22 June 2022

**RE: NEW WEE WAA HIGH SCHOOL (SSD-21854025)
REQUEST FOR ADDITIONAL INFORMATION**

Figure 1 Study area and area of impact assessed under BDAR (left) and Flora and Fauna Assessment (right)

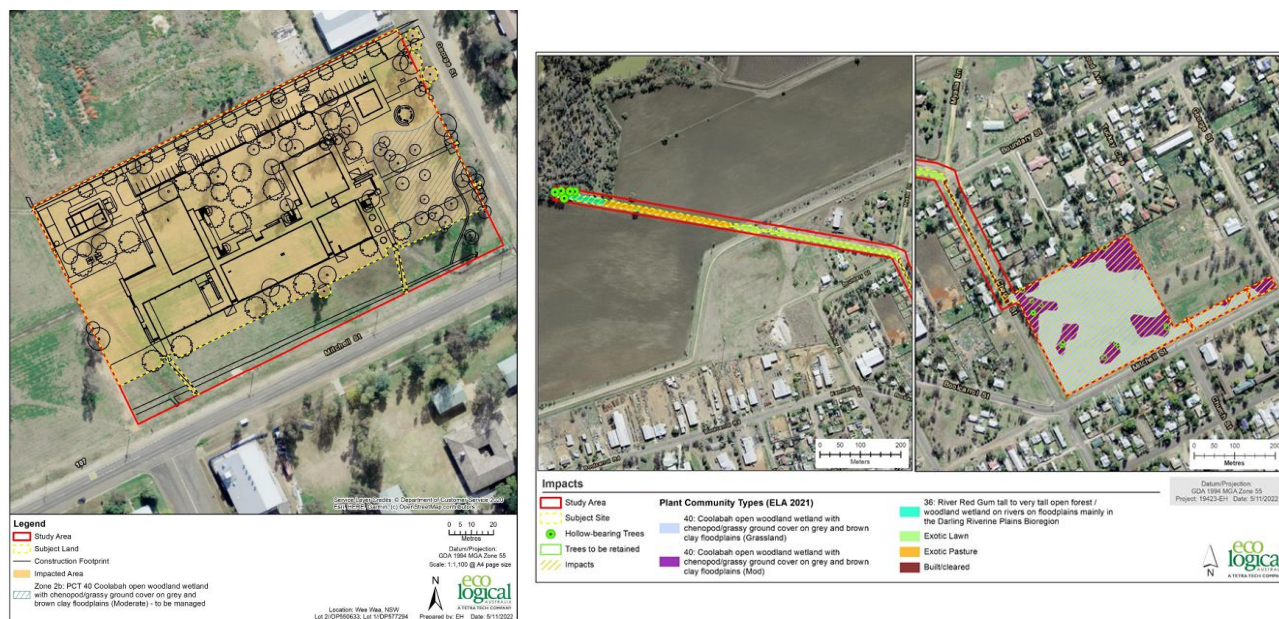
DPE and BCS requested that the environmental assessment (particularly for flooding and biodiversity impacts) associated with the separate but related Part 5 Flood Mitigation Works be provided. This is required so DPE can complete their assessment of the flooding and biodiversity impacts associated with the SSD Application.

The Part 5 environmental assessment has been completed and was determined by DoE on 19 May 2022. A copy of the associated Flora and Fauna Assessment and Flood Impact Assessment has been provided to DPE separately to this response.

The Flora and Fauna Assessment provides an assessment of all vegetation removal to be undertaken under Part 5 in accordance with the *Biodiversity Conservation Act 2016* (BC Act) and the *Environment Protection and Biodiversity Conservation Act 1999* (EPBC Act). All areas of the proposed school site that were not assessed in the BDAR that accompanies the SSD Application have been assessed in the Flora and Fauna Assessment (see **Figure 1**). An updated BDAR is provided at **Attachment I** which makes slight adjustments to the boundary of its assessment to ensure all areas within the site are appropriately assessed between both applications. The Flora and Fauna Assessment concludes that there will not be a significant environmental impact on species. It is worth noting that replacement tree planting exceeding the number being removed is proposed as part of the Part 5 works (through landscaping within the flood mitigation channels) and additional tree planting will take place as proposed in the SSD Application.

Figure 2 Amended site layout plan showing excluded stormwater channel

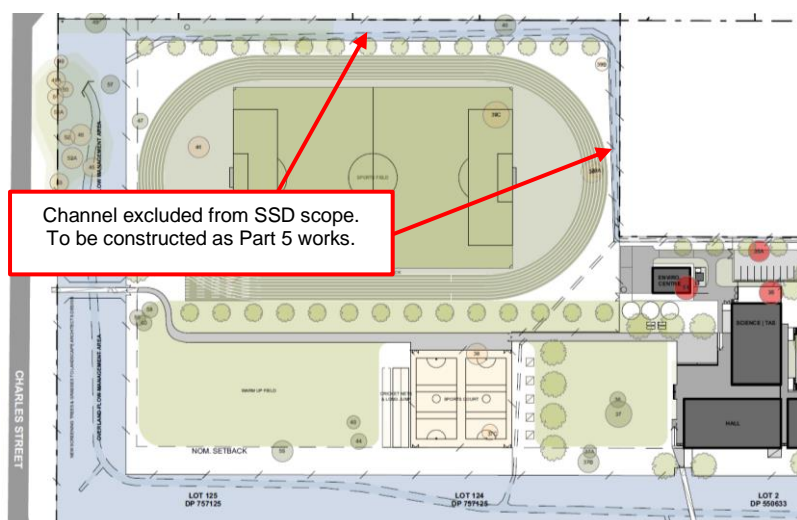
DPE requested clarification of whether the stormwater channel along the northern and north-eastern boundary of the sports fields was to be included in the Part 5 scope or the SSD scope. DPE requested updated architectural drawings be provided as necessary.

The stormwater channel running along the eastern and northern boundaries of the proposed sports fields is included in the Part 5 scope since it is required to convey localised flood and storm water to the primary flood conveyance channel. The Part 5 Review of Environmental Factors includes an assessment of these works and shows no significant impact on the school or surrounding land. Amended Architectural Drawings are provided at **Attachment A**. Also refer to **Figure 2**.

Figure 3 Indicative depth of inundation, 20% AEP event as lodged with EIS (left) and updated (right)

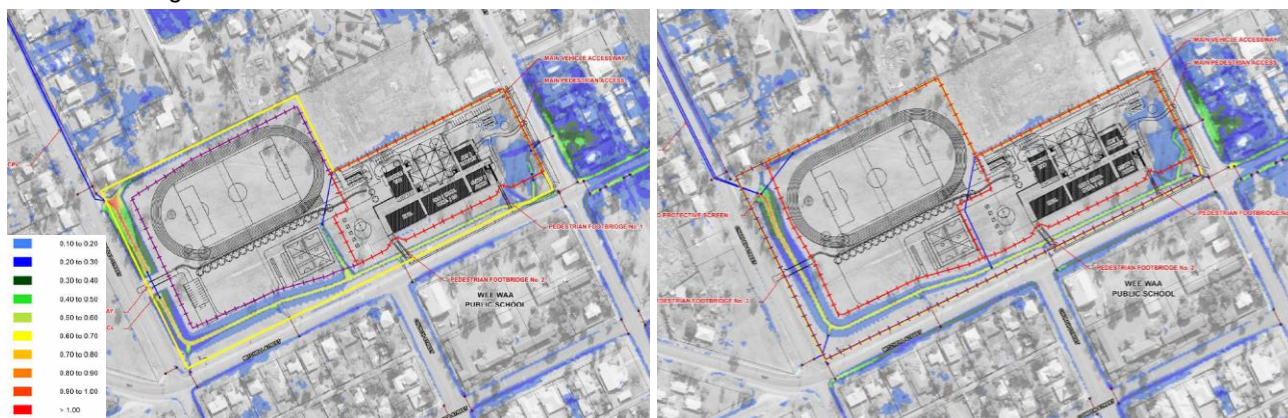
DPE requested that the Flood Impact Assessment be updated to assess the design changes made to the proposal under the previously submitted Submissions Report, as detailed in Council's comments.

Lyall and Associates have provided an Addendum Flood Impact Assessment at Attachment D, which provides the results of the updated flood modelling reflecting changes to the design as per the Response to Submissions and the final Part 5 Flood Mitigation Works Approval. The changes modelled include:

The results of the modelling show that the levels of inundation for all flood events remain very similar to those modelled under the previous arrangement (as lodged with the EIS). A comparison of the indicative depth of inundation within and surrounding the site, for the as-lodged configuration and the amended configuration are provided at **Figure 3** to **Figure 5**.

As can be seen from these figures, the difference in impacts to the subject site and surrounding properties is minimal. Generally speaking, there is a minor increase in the depth of inundation within the eastern portion of the site within the area of retained native grassland, as well as on the eastern side of George Street. To the west and north of the site, there is generally a minor reduction in the amount of inundation, particular for properties to the north of the school site.

The school building area and playing fields remain flood-free for up to the 1% AEP event, meaning the school will remain safe during most flooding events, with flood waters being directed into the flood conveyance channel. Therefore, the amended modelling demonstrates that the revised design results in acceptable flood impacts within and surrounding the site.

Figure 6 Proposed tree removal plan

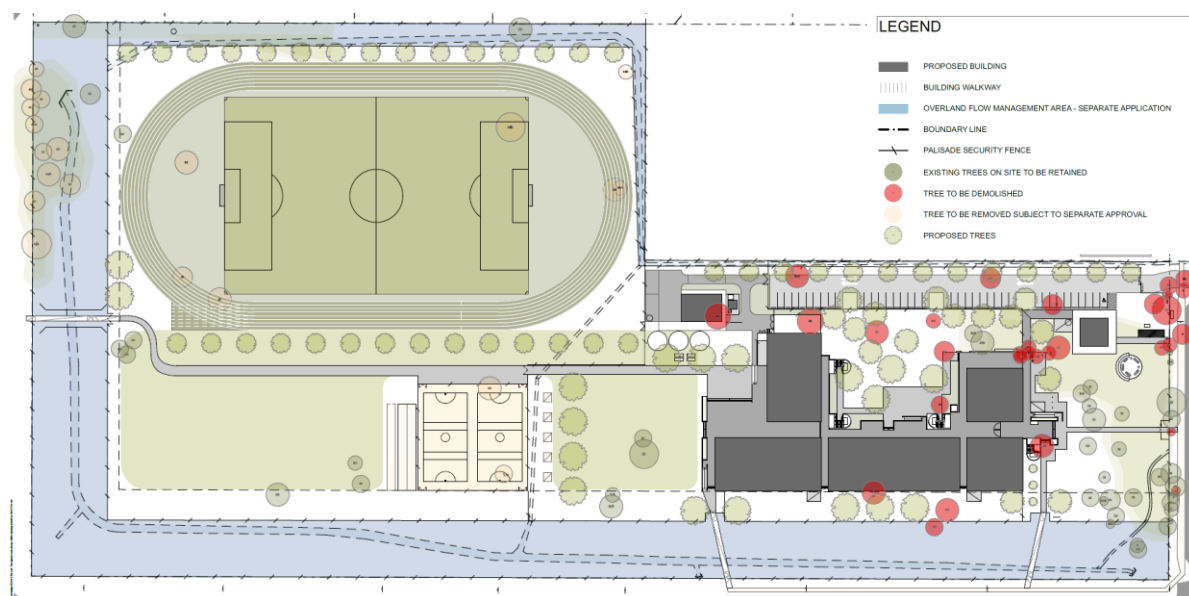
DPE raised concerns that the list of trees proposed for removal in the Submissions Report did not match the Arborist Report.

There are 31 trees proposed to be removed under this SSD Application: Tree 6, 6D, 7C, 7D, 8, 9, 9B, 10, 10A, 11, 12, 13, 14, 14A, 14B, 14C, 14D, 14E, 14F, 26, 27, 28, 29, 30, 31, 32, 33, 34, 35, 35A, and 54. Amended Architectural Drawings, Arboricultural Impact Assessment, Landscape Plans and BDAR have been co-ordinated and are provided as attachments to this RFI Response. A Tree Removal Plan prepared by SHAC is shown at **Figure 6**, which details all trees proposed to be removed in red.
